## PLANNED UNIT DEVELOPMENT

STAFF REPORT Date: June 19, 2003

**DEVELOPMENT NAME** Wimbledon Park Subdivision, Lot G-6

The site is located on the West side of Wimbledon Park West. The plan illustrates the existing and proposed structures.

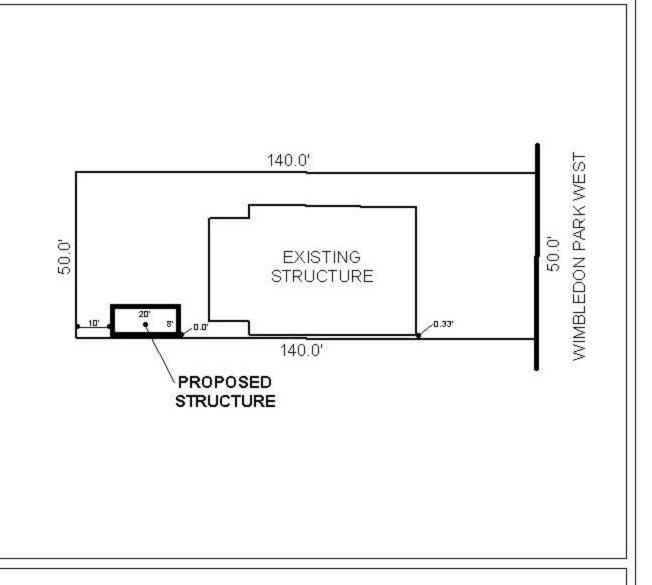
The storage building would be located on the side (South) property line, and the original PUD approval allows a zero setback on the South property line for the lots along Wimbledon Park West. The modification is needed to address the 40-foot setback

from the West property line, as shown on the original PUD. The applicant proposes to locate the storage building approximately 10-feet from the West line.

The Planning Commission has approved modified setbacks for two other lots on Wimbledon Park West, and in both cases the proposed accessory buildings were located on or within five-feet of the West property line. In this case, the applicant would provide a 10-foot setback from the West property line.

**RECOMMENDATION** Based upon preceding, this application is recommended for approval.
